# **Development Review Comments**

April 22, 2025 STP2025-00505 1<sup>st</sup> Submission Review Comments 255 Rockville Pike

The following are Development Review comments from City of Rockville staff related to the project submission.

HUNGERFORD DRIVE (MD-355) FUTURE (BRT) SECTION

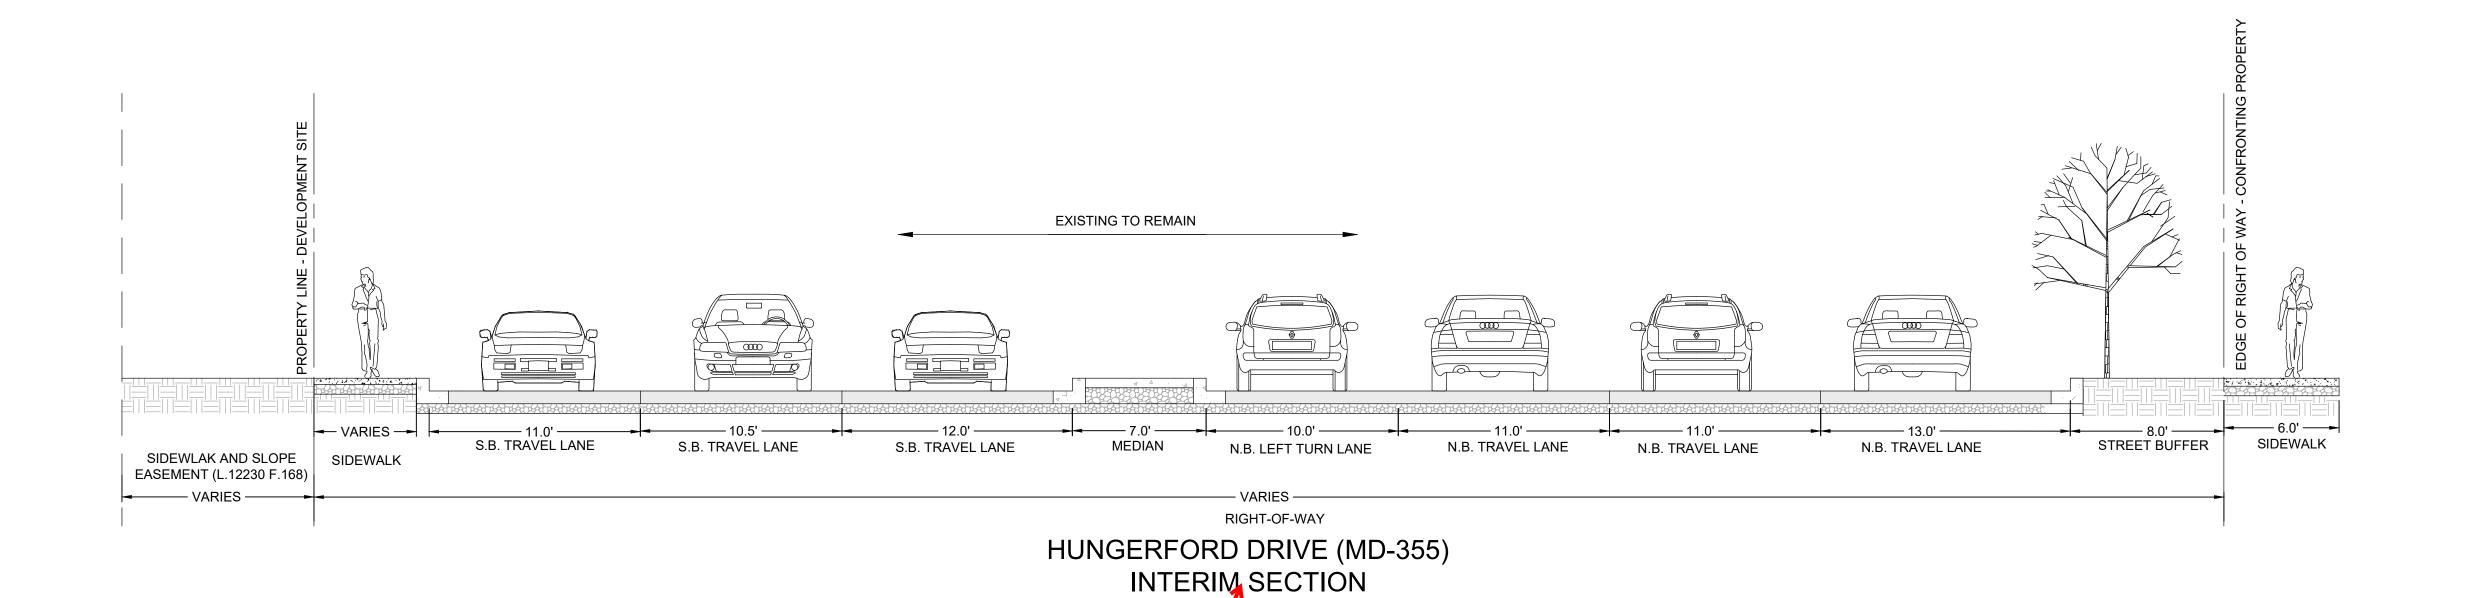
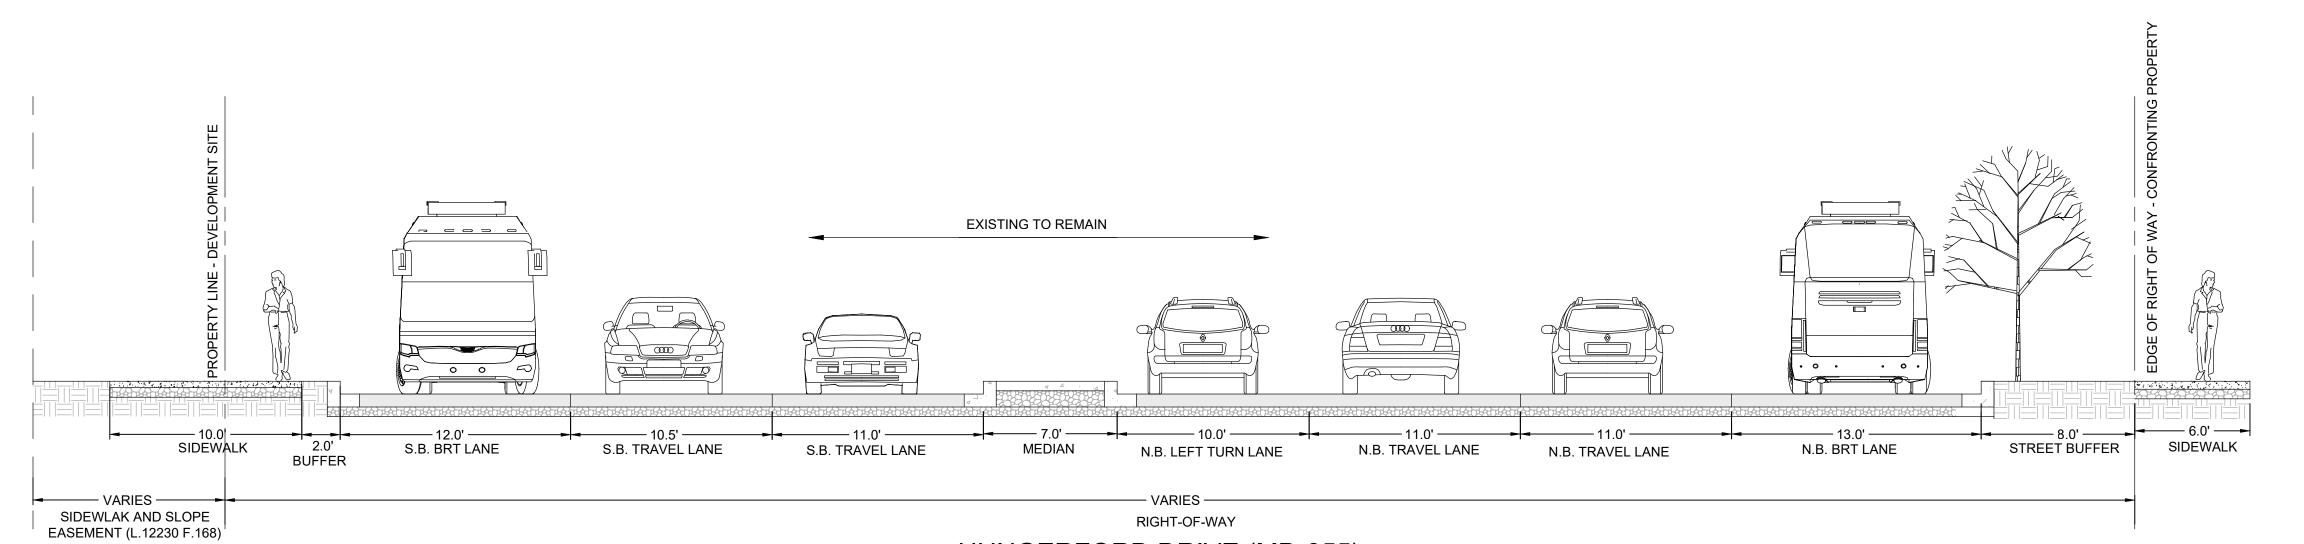
remove future section if proposed by others
